Study Area Context

Municipal Class Environmental Assessment Study for Creditview Road
from Bancroft Drive to Old Creditview Road

Comment Sheet Summary and Response Tables

Design Alternatives

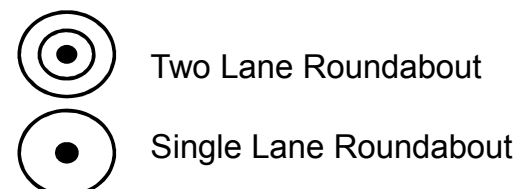
Category	Comment	Response/How Concern Will Be Addressed
Safety	<ul style="list-style-type: none"> Increased traffic will impact pedestrian safety. Safety concerns at the Creditview Road/Kenninghall Boulevard intersection as school bus drop off/pickup requires students to cross Creditview Road. Concerns on speeding (particularly north of Kenninghall Boulevard). 	Both the City and the Project Team understand and appreciate the importance of safety. The Project Team welcomes all input from residents who reside within the area that can provide important local knowledge on current problems, as well as the types of mitigation measures they would like to see implemented. The Project Team has undertaken a comprehensive traffic safety study, which has been considered in the evaluation of the alternatives.
	<ul style="list-style-type: none"> The right turn lane to Bancroft Drive from Creditview Road north is not being used as intended. Many drivers continue north on Creditview Road which is a safety issue. 	The transition lane has been removed north of Bancroft Drive on Creditview Road. The right turn lane will be used as intended.

<ul style="list-style-type: none"> Greater enforcement by police is required to enforce the truck restriction. 	Issue requires additional enforcement and will be brought to the attention of Peel Police and the City of Mississauga By-Law Officers.
Traffic	<ul style="list-style-type: none"> Turning out of Velebit Court is difficult, especially during rush hour. 	All of the noted concerns and suggestions have been considered in the evaluation of the alternatives.
	<ul style="list-style-type: none"> Review traffic signal synchronization. The left turn signal from northbound Creditview Road to Kenninghall Boulevard should be at least between 4 pm and 7 pm. Remove the left turn prohibition from southbound Creditview Road to Bancroft Drive during morning rush hour. Add left turn signal for northbound Creditview Road/Sir Monty's Drive. Left turns at this intersection are dangerous in the evening. 	The existing traffic operation concerns will be reviewed with the City's Traffic Engineering and Operations Section.

<ul style="list-style-type: none"> If improvements are made, use the centre lane as a reversible flow lane. 	Reversible lanes work best when the peak traffic direction changes between the morning and afternoon peak travel periods. This does not occur on this road where the traffic directions remain constant throughout the day; and providing reversible lanes requires the installation of extensive wiring and signals above the road to control the directions of traffic, and this would have a significant impact on the scenic value of the road.
Wildlife Concerns	<ul style="list-style-type: none"> Both turtle and deer have been observed crossing the roadway. Bird nesting (heron, owl, and hawk) has also been observed in the vicinity of the roadway. Wildlife habitat within and in the vicinity of the Credit River and adjacent natural areas needs to be preserved. How will improvements to Creditview Road factor in concerns for wildlife? 	The Project Team has undertaken wildlife and terrestrial assessments to identify any impacts to species and their habitats as a result of improvements to Creditview Road. Although the limits for this study are from Bancroft Road to Old Creditview Road, we anticipate minor, if any impact on the Credit River. Comments received at the PIC regarding wildlife in the vicinity of the Creditview Road Bridge over the Credit River have been forwarded to the project team responsible for the detail design of the bridge.

Vegetation	<ul style="list-style-type: none"> Concern over potential for loss of vegetation, including existing trees lining roadway and effects on Natural Areas in the vicinity of the Credit River. How will improvements to Creditview Road lessen effects to existing vegetation? 	A tree inventory and assessment has been completed as part of this Class EA study. A tree protection and planting plan will be established. Tree protection fencing will be maintained during construction.
